Summary Table of Changes to Drawing R86000 Rev L to Rev M

Revision 3 to the Sentry 110, Sentry 330 and 867 SAR changes are described as follows and listed under the SAR Section in Revision 3 where the change occurs.

June 2015 - Revision 3
Page 1-2

Figure 1.2e: Model 867 Lock Assembly Components

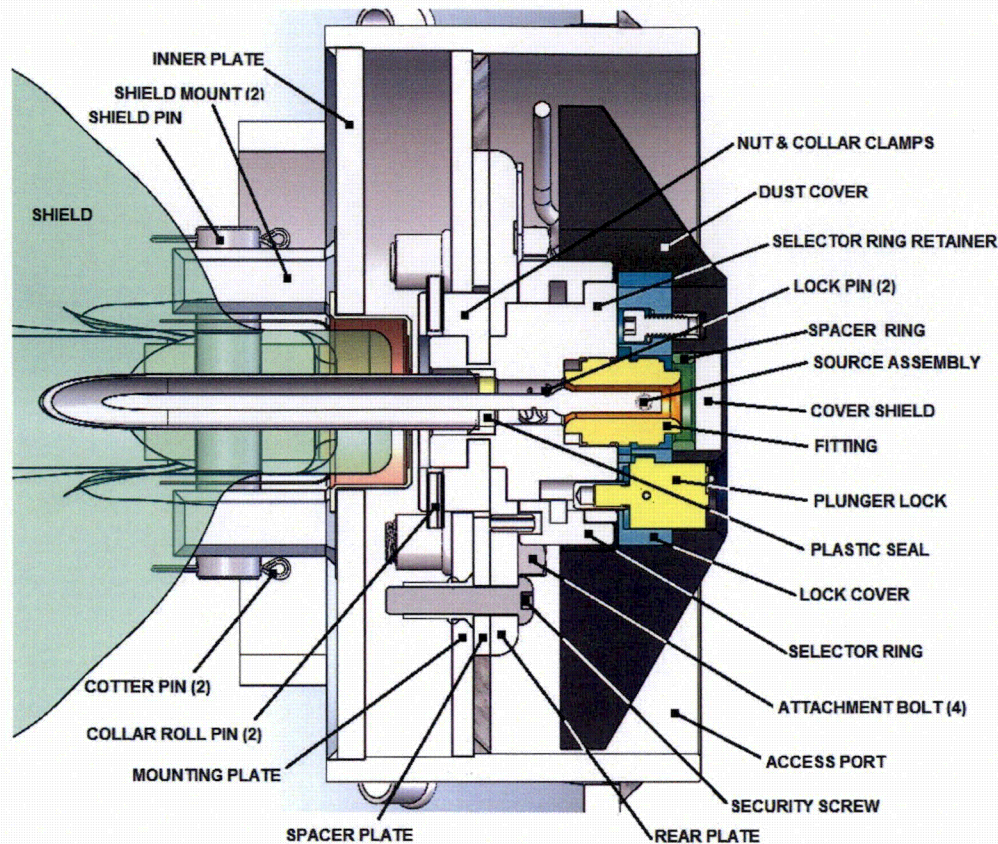
| Section Location | Summary Change | Change Reported Pursuant to 71.95 | Impact of Change on Units Previously or Currently in Use under the Certificate | Action Taken By QSA Regarding Affected Units |
|--|---|---|--|--|
| Figure 1.2e | Figure updated to show cover shield component added to Model 867 dust cover assembly. | No | No impact. Addition of cover shield will only impact units transported after approval of NRC CoC amendment. | None. Not applicable |

Figure 2.6f – 1.2 m (4 ft) Drop Orientation TP180J

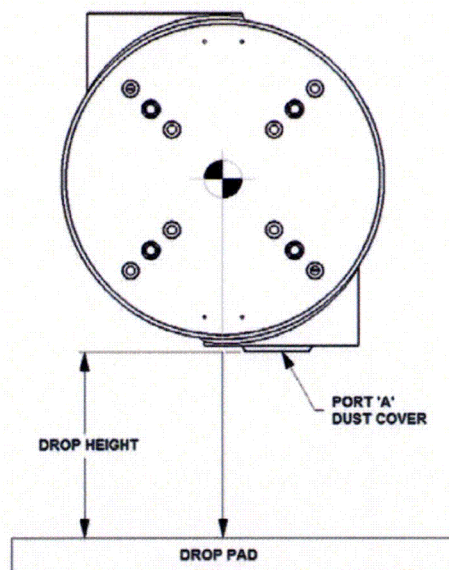
| Section Location | Summary Change | Change Reported Pursuant to 71.95 | Impact of Change on Units Previously or Currently in Use under the Certificate | Action Taken By QSA Regarding Affected Units |
|---------------------------|--|-----------------------------------|---|--|
| Section 2 Figures | Figure references updated as necessary based on addition of drop test figure orientations for test specimen TP180J | No | No impact. Administrative change only. | None. Not applicable. |
